**FINAL REPORT – INSPECTION 2009-12910-02 – PEER REVIEW OF DIKE C
BUTTRESSING**

Peer Review of Stantec Consulting Services, Inc.
Dike C Buttress, Stage 1 Construction – Segment “D”
Dated September 23, 2010

Peer Review of Stantec Consulting Services, Inc. (Stantec)
Dike C Buttress, Stage 1 Construction – Segment “D”
Supporting Stability Calculations, Drawings, Technical Specifications, and Quality Control Plan
Tennessee Valley Authority Kingston Fossil Plant (KIF) – Harriman, Roane County, TN

For the drained shear strength parameter case, the slope stability results for the stability section at station 138+27 are shown on Drawing XXWXXX-11 in Appendix A. With the stage 1 buttress in place the lower toe potential slip surface B has an estimated factor of safety of

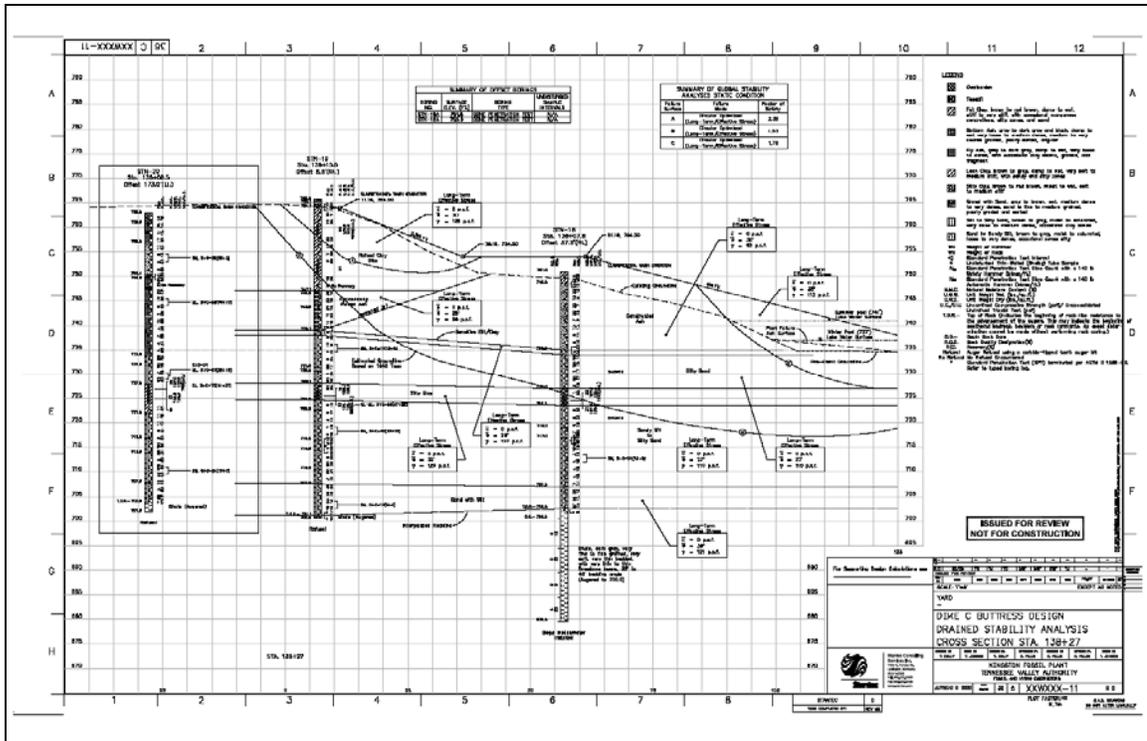
Stantec did not prepare a direct comparison of slope stability factors of safety for the existing and buttressed dike configurations at critical sections, so the relative improvement in stability afforded by the Stage 1 Buttress Construction is not clearly documented.

The two critical sections analyzed within segment D (Sta 138+00 to Sta 160+00) are located at station 138+27 and station 149+14. Each critical section along with existing (pre-buttressed condition) and current (buttressed condition) long term slope stability factors of safety are discussed below.

1.53 with the buttress in place, an increase of 0.40 from the factor of safety of 1.13 for a similar potential slip surface for the existing conditions. The overall potential slip surface C has an estimated factor of safety of 1.76 with the buttress in place, or an increase of 0.24 over the existing stability condition.

Slope Stability Output -
Undrained Buttressed
Condition

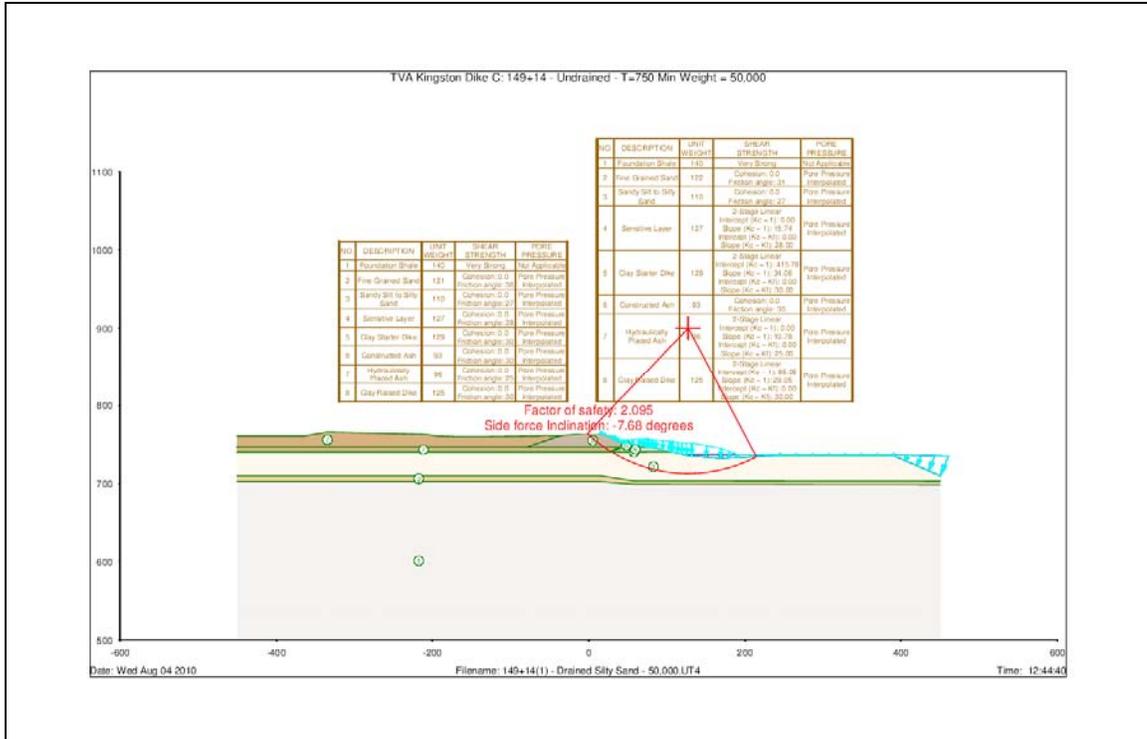
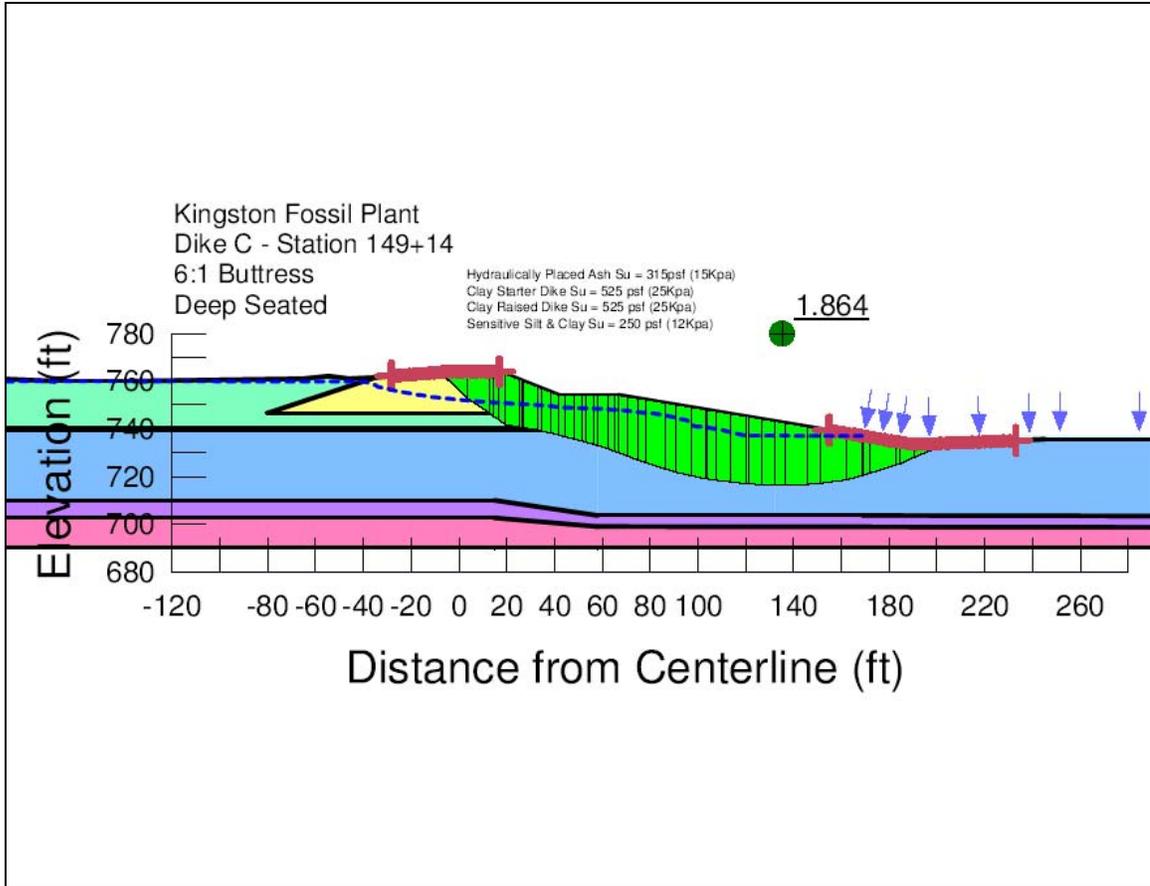
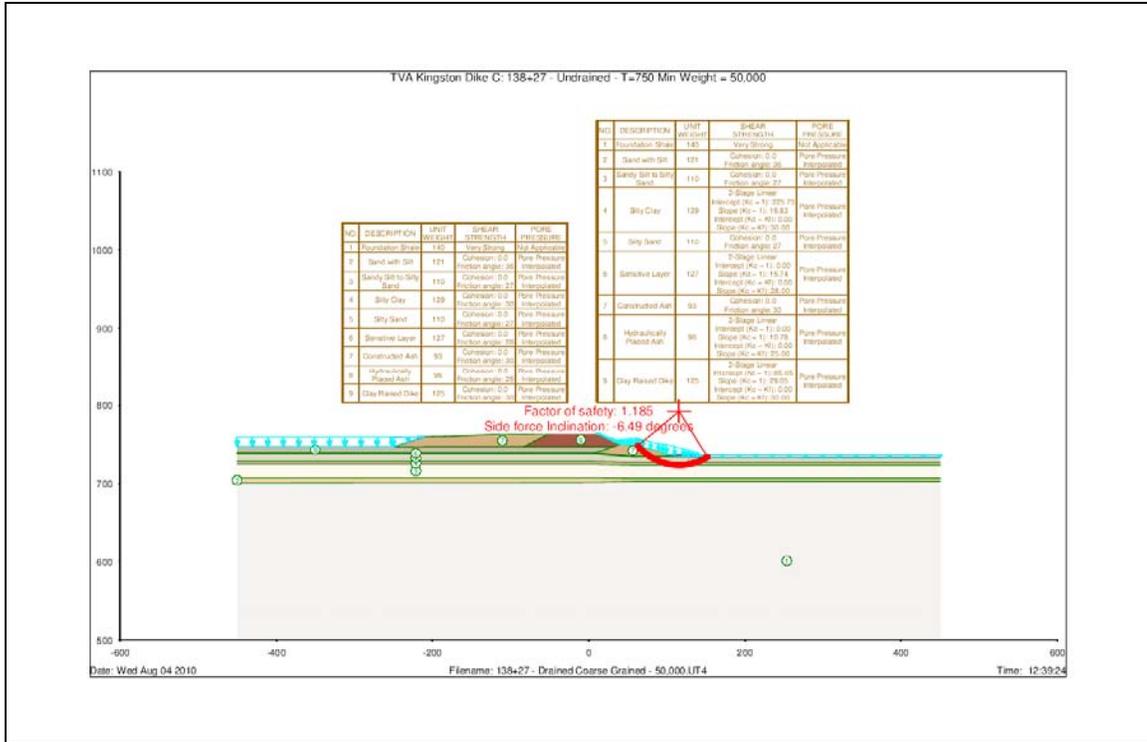
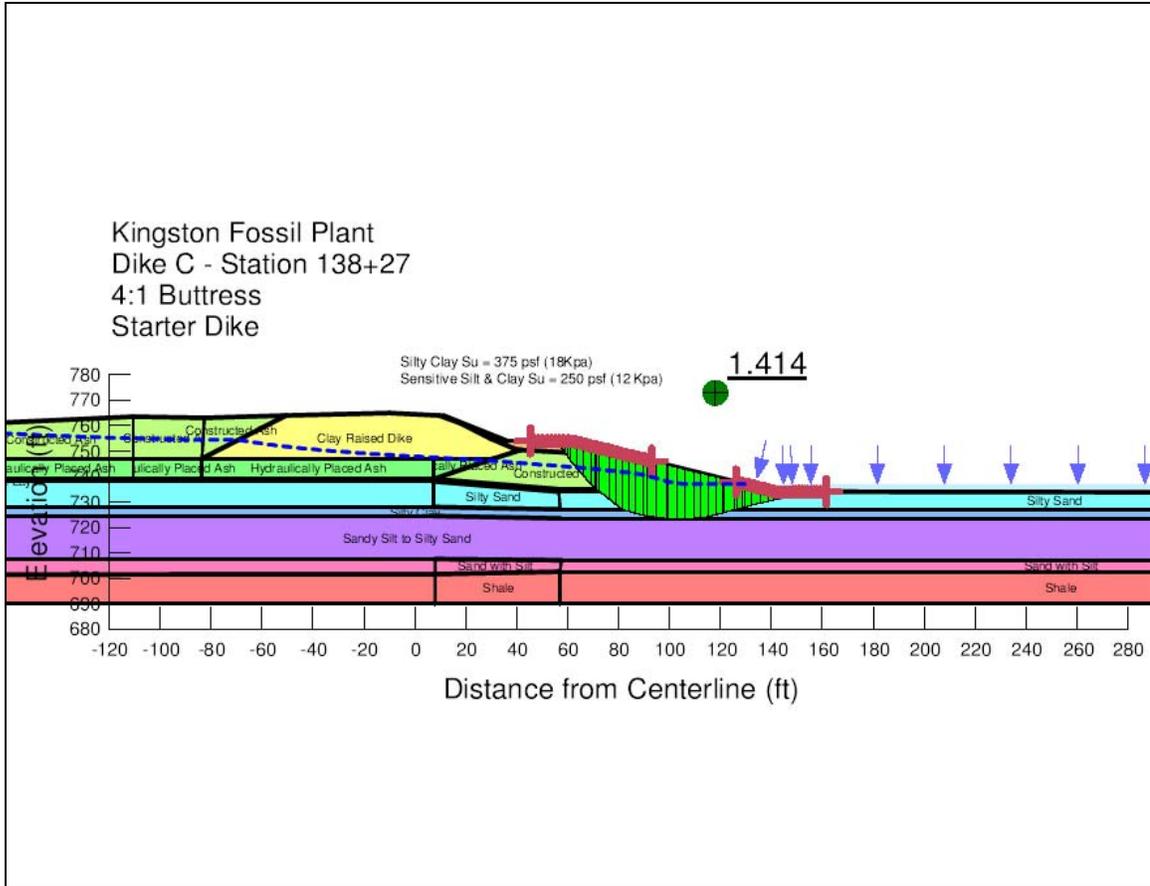
Stantec did not perform an undrained slope stability analysis for the buttress construction case, or other load cases that could prompt undrained behavior of the dike and foundation materials (rapid drawdown and earthquake/seismic cases). With regard to the construction case and associated rate of loading issues, the starter dike is constructed of clayey materials and, in Marshall Miller's professional opinion, is subject to undrained loading during buttress construction. Also, subsurface profiles in the previously referenced Stantec geotechnical report indicate zones and layers of clayey material within the foundation, which could impede drainage and contribute to undrained loading of even the silty sand to sandy silt foundation soils.

For the stability section at Sta. 149+14, the slope stability output plots are included on Figures 1B and 2B in Appendix B. Figure 1B shows the UTEXAS4 output assuming the Stage 1 buttress has been constructed to 6H:1V. Using the drained and undrained strength parameters as outlined above on Table 1, the critical slip surface for this cross section corresponds to an overall deep seated surface with an estimated factor of safety of 2.10 as shown on Figure 1B in Appendix B.

As a further check on the slope stability using undrained strength parameters, SLOPE/W was also used by converting the undrained shear strength parameters for the hydraulically placed ash, the starter and raised clay dike materials and the sensitive silt and clay material to equivalent undrained strengths assuming $\phi_u=0$. This was done by determining the average effective stress within the various materials prior to the buttress construction and then estimating the equivalent average undrained shear strength value assuming $\phi_u=0$. The material strengths for all other materials follow that given on Table 1. By using this conversion method, the estimated undrained strength of the hydraulically placed ash was 315 psf, the starter and raised clay dike undrained strength was 525 psf, and the sensitive silt and clay undrained strength was 250 psf. For this scenario using SLOPE/W, the critical slip surface is shown on Figure 2B in Appendix B and has an estimated factor of safety of 1.93.

For the stability section at Sta. 138+27, the slope stability output plots are included on Figures 3B and 4B in Appendix B. Figure 3B shows the UTEXAS4 output assuming the Stage 1 buttress has been constructed to 4H:1V. Using the drained and undrained strength parameters as outlined above on Table 1, the critical slip surface for this cross section corresponds to a lower toe relatively shallow surface with an estimated factor of safety of 1.19 as shown on Figure 3B in Appendix B.

equivalent undrained shear strength of the sensitive silt and clay was estimated to be 250 psf, and 375 psf for the silty clay material. For these conditions and using SLOPE/W, the critical slip surface is shown on Figure 4B in Appendix B and has an estimated factor of safety of 1.41.
